Access Compliance Report Public Rights-of-Way (Curb Ramps)

Main Street: WHIDBEY_DR Cross Street: BAINBRIDGE_AVE Location: SW

ADA ID: RPRK2111151212 Ramp Type: Type 4 - Parallel Initial Pass/Fail: Pass Overall Compliance: No Severity Score: 26

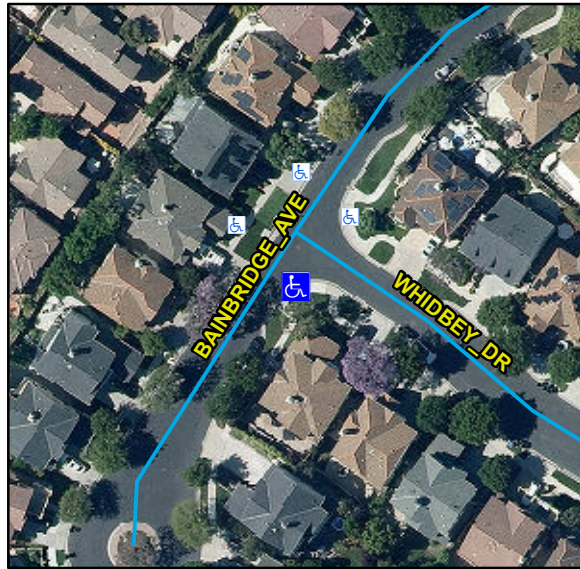
Compliance	Description	Data	Compliance	Description	Data
N/A	Ramp Length LT (in)	133	N/A	Ramp Length RT (in)	141
Yes	Ramp Width LT (in)	52	Yes	Ramp Width RT (in)	50
Yes	Ramp Run Slope LT (%)	1.8	Yes	Ramp Run Slope RT (%)	5.8
No	Ramp Cross Slope LT (%)	2.6	Yes	Ramp Cross Slope RT (%)	1.2
N/A	Landing Present	No	No	DWS Provided	No
N/A	Landing Length (in)	N/A	N/A	DWS Contrast	N/A
No	Landing Width (in)	N/A	N/A	DWS Length (in)	N/A
No	Landing Run Slope (%)	N/A	N/A	DWS Full Width	N/A
No	Landing Cross Slope (%)	N/A		DWS Offset Type	N/A
N/A	Landing Movement Obstructed?	No	N/A	DWS Offset Left (in)	N/A
	Landing Movement Type	Curb	N/A	DWS Offset Right (in)	N/A
N/A	Landing Shared	N/A			
N/A	Clear Space	Yes			
N/A	Clear Space To Crosswalk (in)	48			
N/A	Marked Crosswalk 1	No	N/A	Marked Crosswalk 2	No
	Crossing 1 Direction	NE		Crossing 2 Direction	NW
	Marked Crosswalk 1 Width (in)	N/A		Marked Crosswalk 2 Width (in)	N/A
N/A	Ramp Inside Crosswalk 1	N/A	N/A	Ramp Inside Crosswalk 2	N/A

Crossing 1 Slope (%)	2.2		Crossing 2 Slope (%)	0.6
	Crossing 1 Cross Slope (%)	2.6		Crossing 2 Cross Slope (%)	1.7
No	Gutter Ponding	Yes	Yes	Curb Slope	0.7
Yes	Gutter Lip Height (in)	0		Road Run Slope (%)	1.2
No	Gutter Run Slope (%)	5.5		Road Cross Slope (%)	1.7
Yes	Gutter Cross Slope (%)	1.8	No	Perpendicular Joint Present	No
Yes	Overall Surface Condition	Acceptable			
	Cross Gutter Present?	No		Spandrel Present?	No
	Replace Cross Gutter?	N/A		Replace Spandrel?	N/A

Remove & Replace Curb Ramp With Two New Directional Ramps or Equivalent. Remove & Replace Gutter.
